## **Access Compliance Report Public Rights-of-Way** (Curb Ramps)

Intersection ID: 43227 Main Street: N\_I-77\_EXIT\_5\_RA Cross Street: N I-77 HY Location: SE **Overall Compliance: No** ADA ID: EB3BA30C48D2 Ramp Type: Perp Initial Pass/Fail: Fail **Severity Score:** 8.75

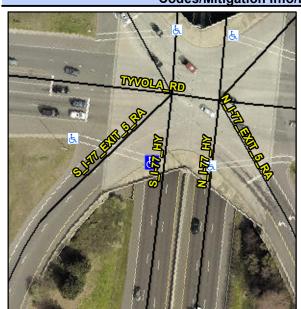
Possible Solutions: Remove & Replace Entire Ramp. Surveyor Notes: N/A PROW/ADA: R304.5.1

Field Measurements/Component Compnance					
Compliance Description		Data	Compliance Description		Data
N/A	Ramp Length (in)	87.0	Yes	Ramp Slope (%)	5.4
No	Ramp Width (in)	36.0	Yes	Ramp XSlope (%)	1.7
N/A	Flare Type LT	N/A	N/A	Flare Type RT	N/A
N/A	Flare Slope LT (%)	N/A	N/A	Flare Slope RT (%)	N/A
N/A	Flare Traversable LT?	N/A	N/A	Flare Traversable RT?	N/A
N/A	Landing Length (in)	N/A	N/A	DWS Provided?	N/A
N/A	Landing Width (in)	N/A	N/A	DWS Contrast?	N/A
N/A	Landing Slope (%)	N/A	N/A	DWS Length (in)	N/A
N/A	Landing X Slope (%)	N/A	N/A	DWS Full Width?	N/A
N/A	Landing Curb? (Y/N)	N/A	N/A	DWS Offset (in)	N/A
N/A	Shared Landing?	N/A			
N/A	Gutter Ponding?	N/A	N/A	Gutter Slope (%)	N/A
N/A	Gutter Lip Ht (in)	N/A	N/A	Gutter X Slope (%)	N/A
N/A	Painted X Walk1?	Yes	N/A	Painted X Walk2?	N/A
	X Walk 1 Direction	To NW		X Walk 2 Direction	N/A
N/A	X Walk 1 Width (in)	74.0	N/A	X Walk 2 Width (in)	N/A
	X Walk 1 Slope (%)	2.9		X Walk 2 Slope (%)	N/A
